PLANNING & ZONING COMMISSION MEETING

DSI Huxley Site Plan, Huxley Development Park

Response Letter

Re: DSI Huxley – Site Plan Review

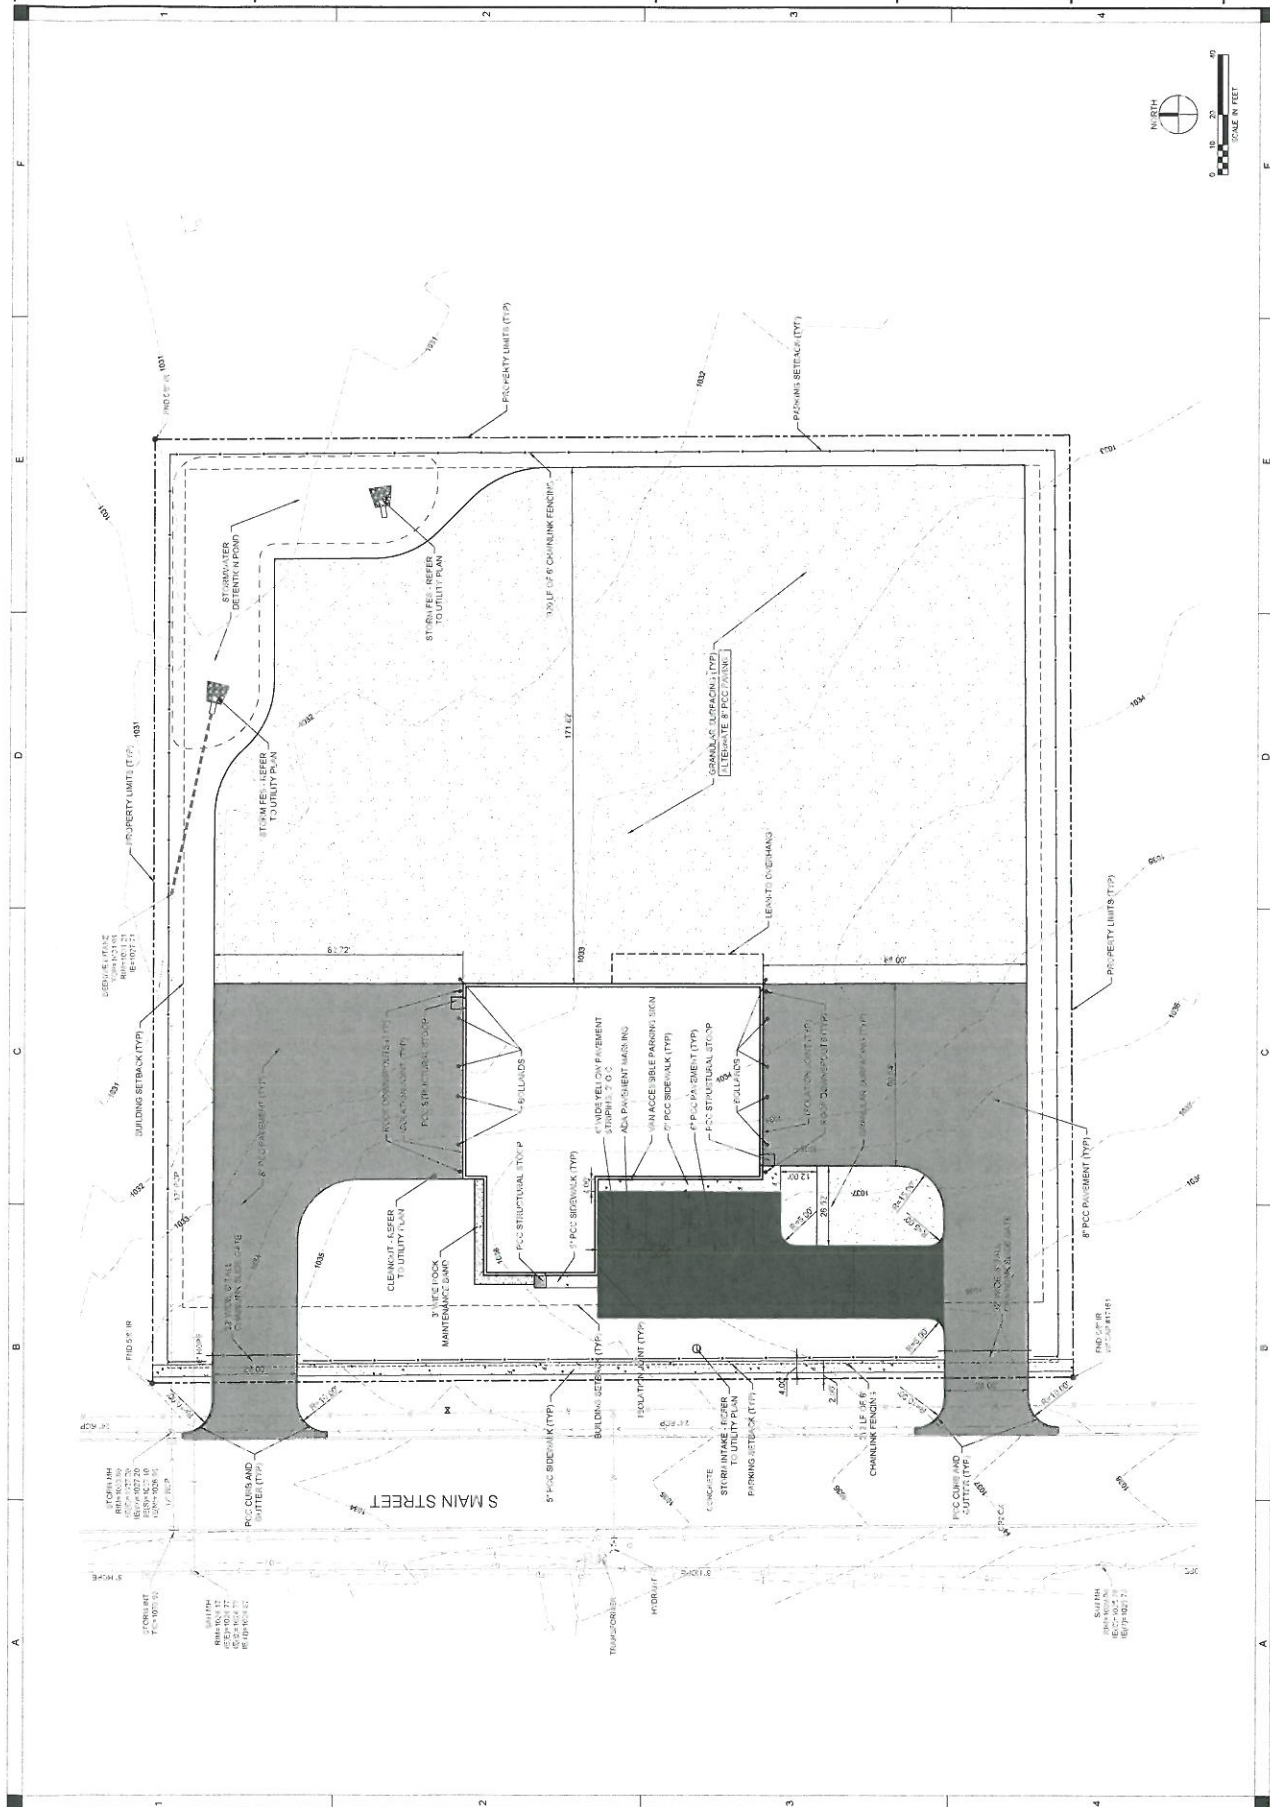
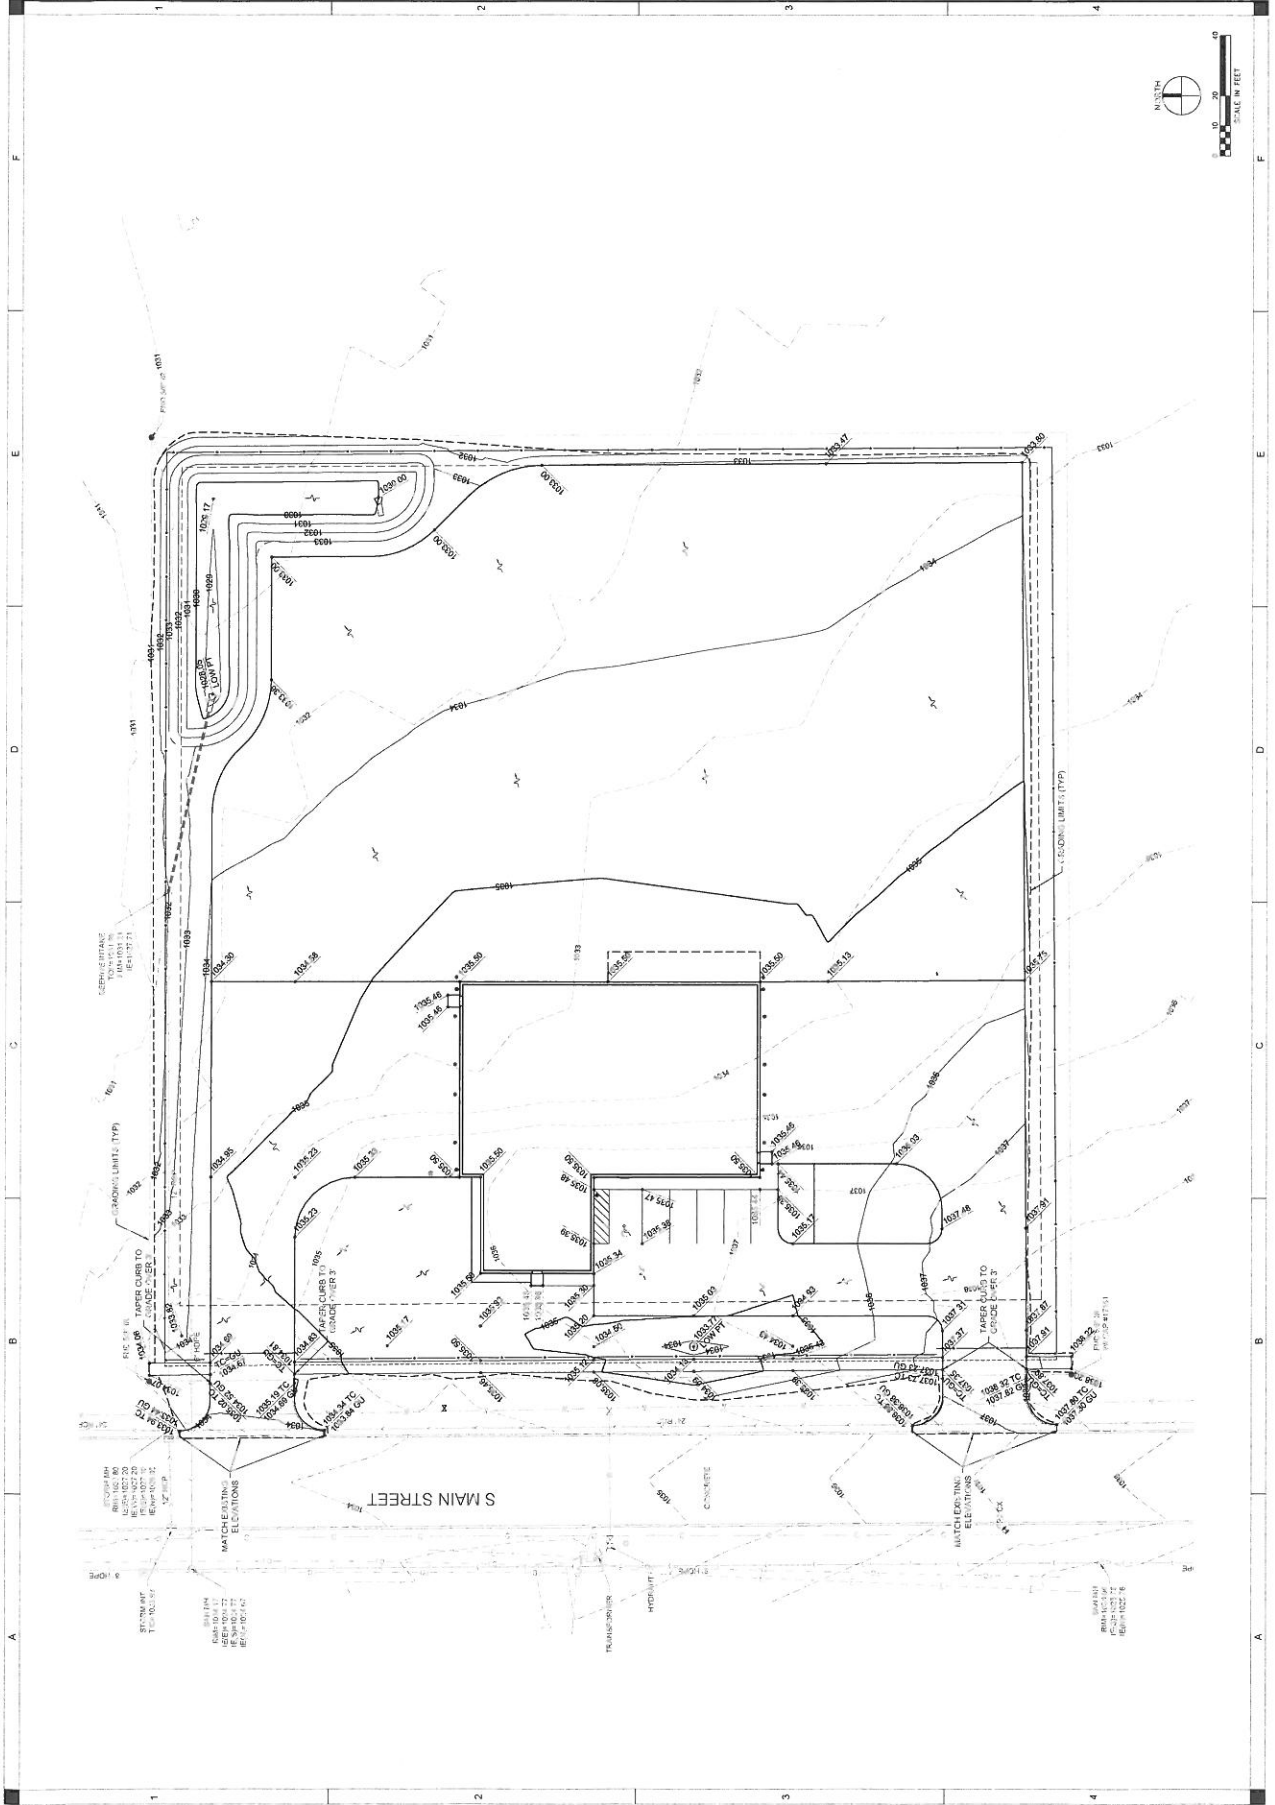
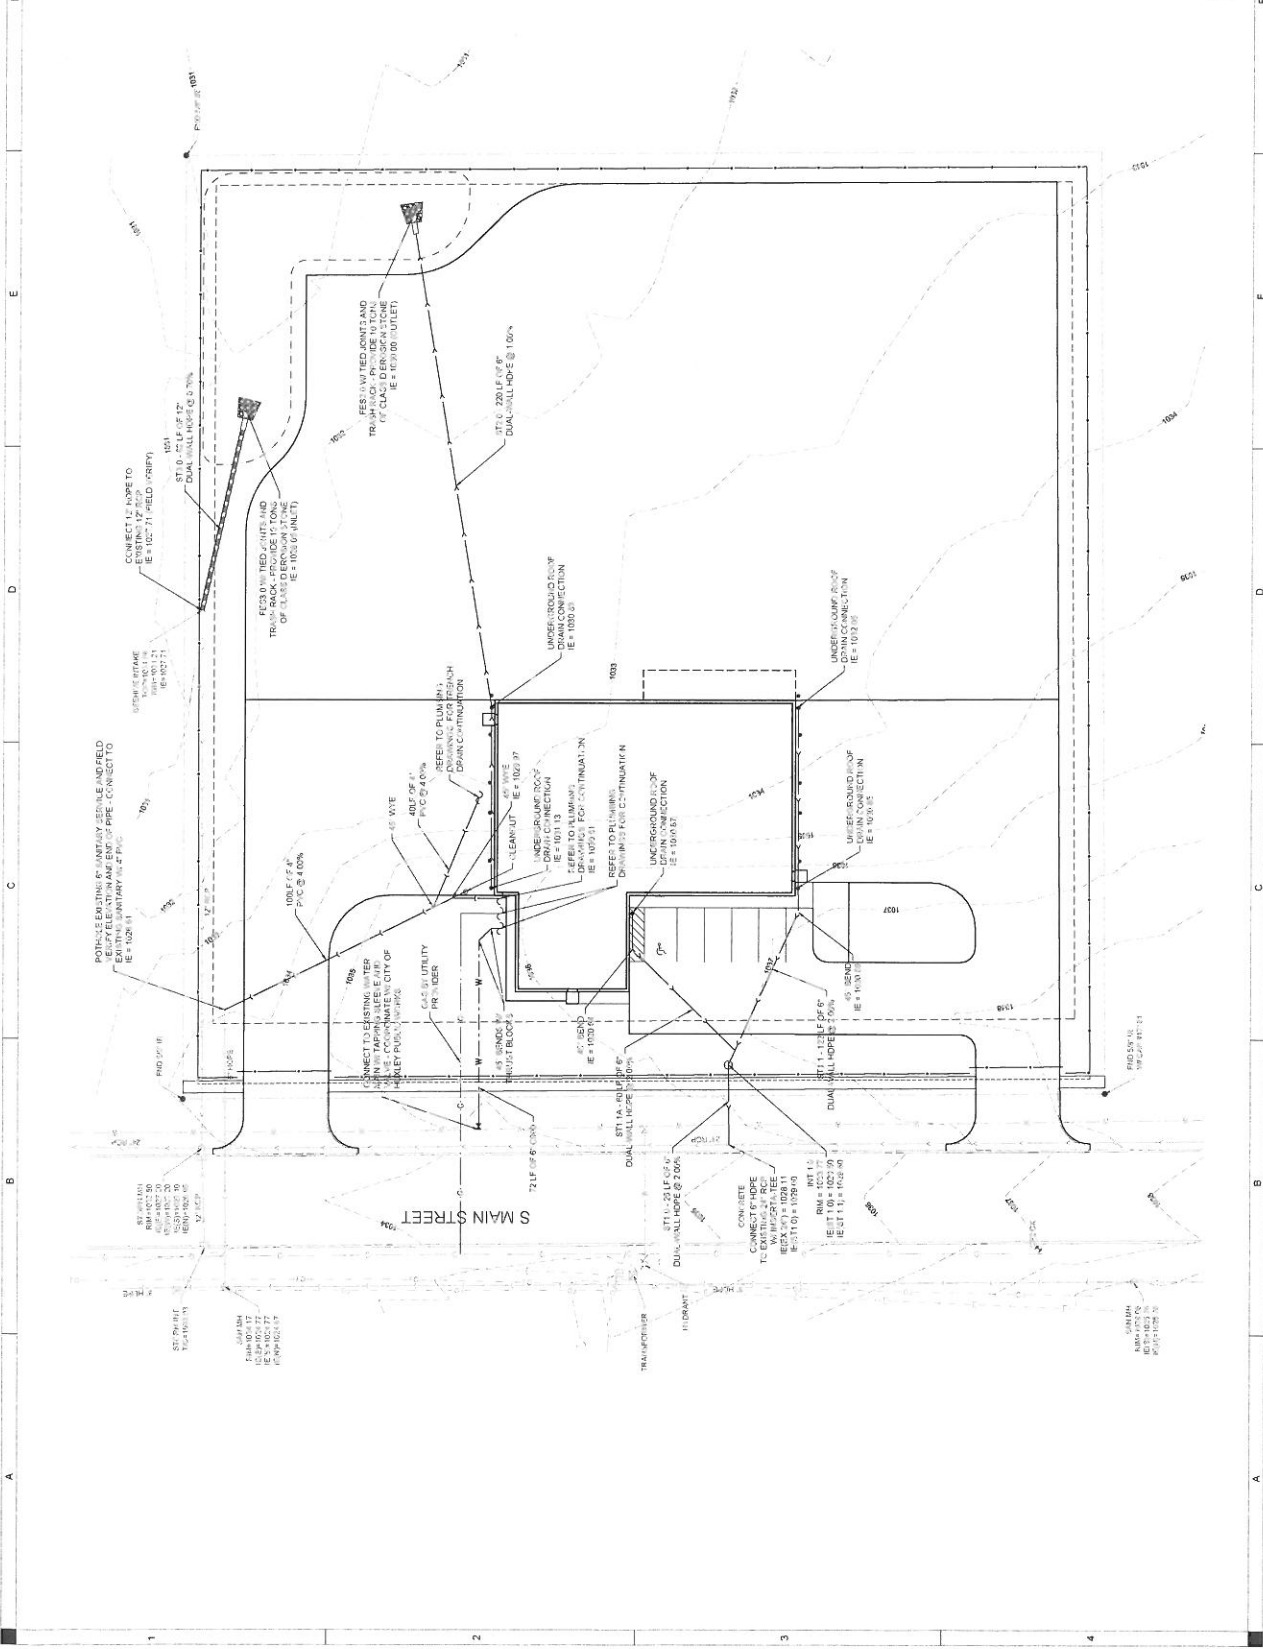
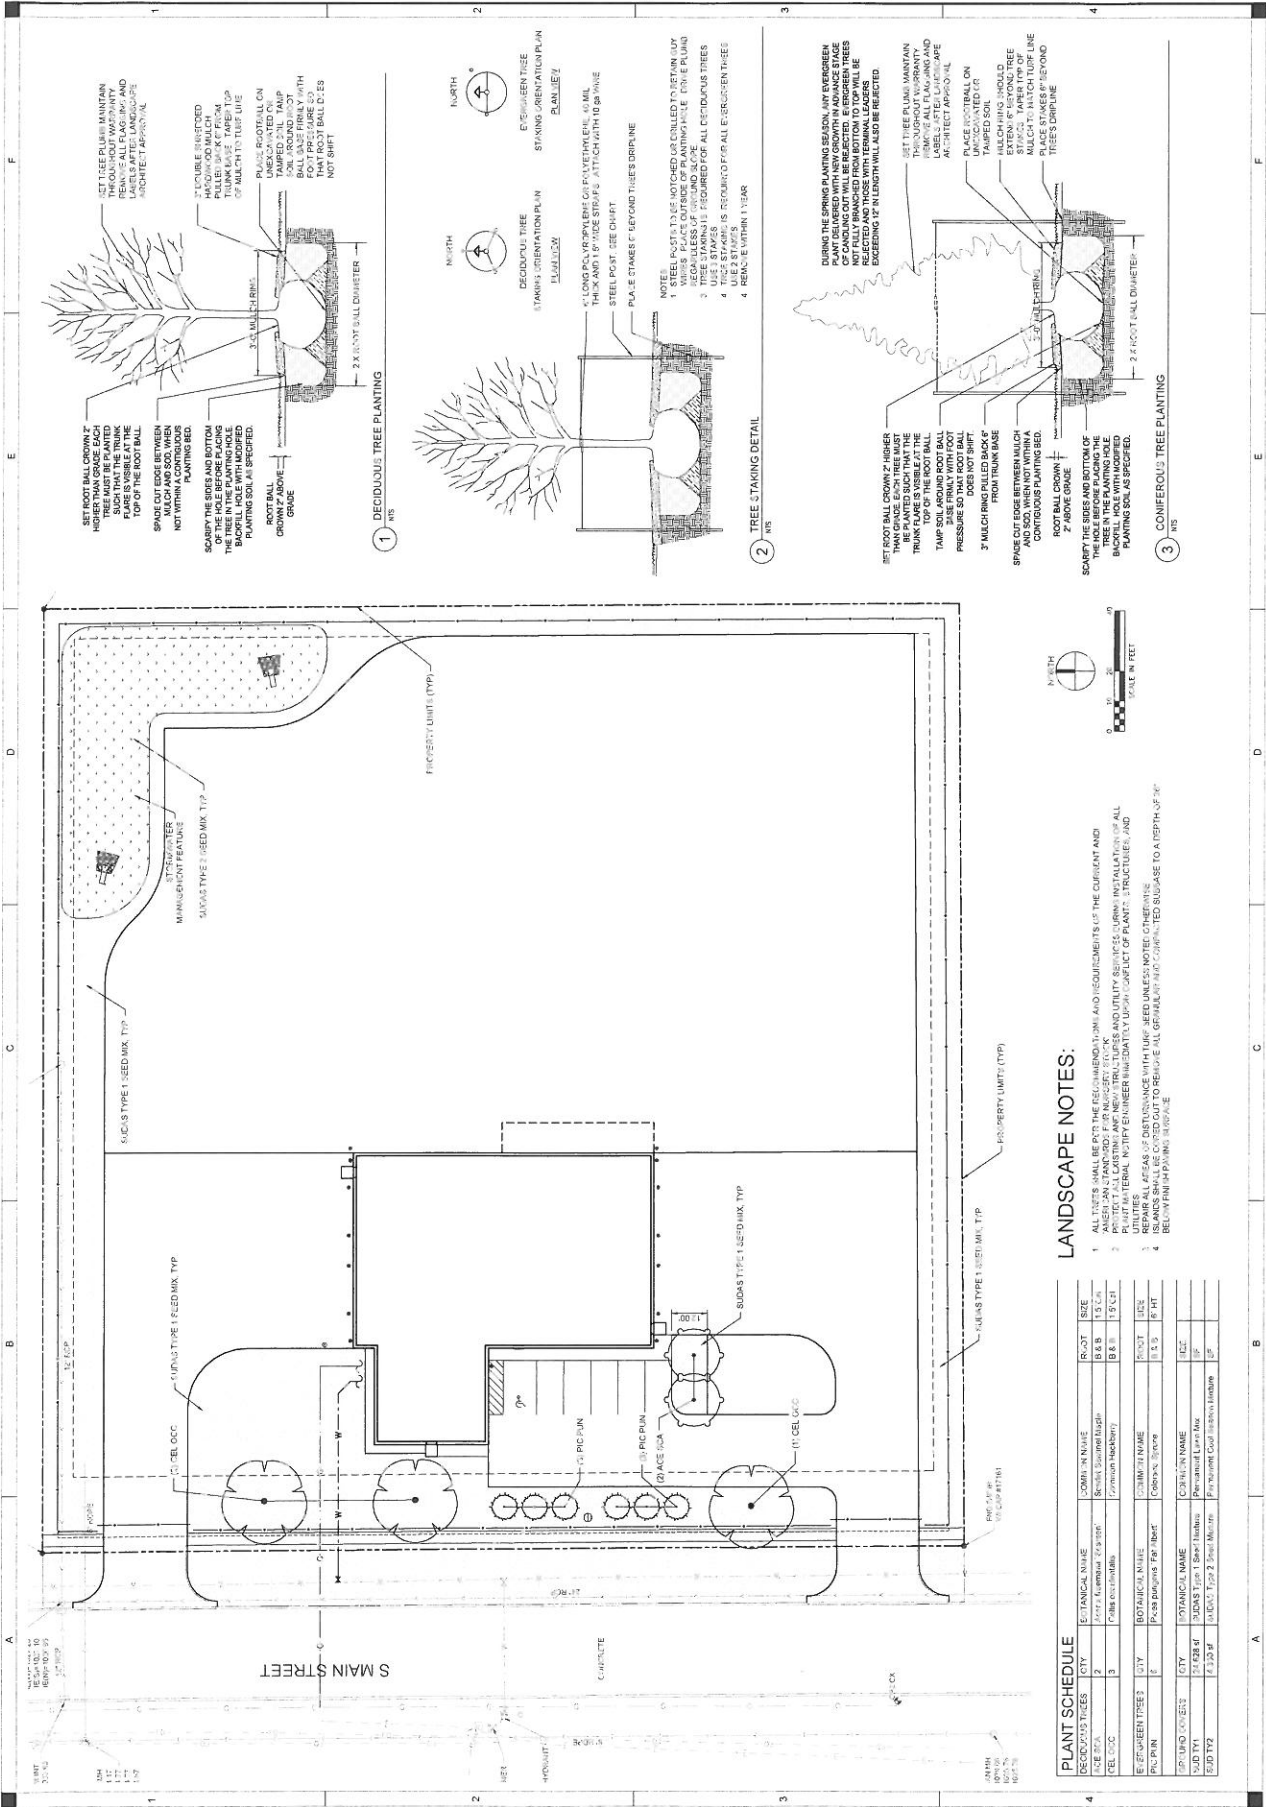
3. The detention basin berm should have a side slope of 4:1 or flatter in accordance with SUDAS Design Manual Section 2G-1.F.1.a.
S-H Response: Slopes of detention basin are updated to meet 4:1 maximum side slope.

4. Label the storm sewer from the public storm sewer on the east side of Main Avenue to the intake as "Private."
S-H Response: Note has been added to denote private storm sewer.

5. Label the storm sewer from the street manhole to the pond outlet structure as "Private."
S-H Response: Note has been added to denote private storm sewer.

6. Change street name to S. Main Avenue.
S-H Response: Update has been made to base file.
7. Provide 5-foot wide sidewalk along the street.
S-H Response: 4' Sidewalk previously shown has been widened to 5' and moved within City ROW.

8. Provide dimensions for the boundary of the lot.
S-H Response: Boundary dimensions have been added to base file.
9. Provide calculations showing a minimum of 20% greenspace on the site.
S-H Response: Greenspace calculations has been added to Cover Sheet – C000.

14. Show P.U.E. and other easements from the Industrial Final Plat on the site plan.

15. Provide building dimensions and building square footage.

20. The maximum total allowable release rate from the site for both detention basins is 1.5 cfs. See the attached stormwater management plan for the Huxley Industrial Park dated January 17, 2006.

21. Revise and re-submit the stormwater management calculations for the site.

S-H Response: Grading of site has been reworked to accommodate drainage from South and East of the building to the NE detention basin.

S-H Response: Stormwater report is being reviewed to ensure total release rate is met.

S-H Response: Stormwater management report has been updated including associated calculations.

S-H Response: Embankment width has been updated to meet SUDAS requirements.

S-H Response: Freeboard and emergency spillway requirements are being reviewed to ensure SUDAS requirements are being met.

S-H Response: West stormwater basin is updated and contained within the site.
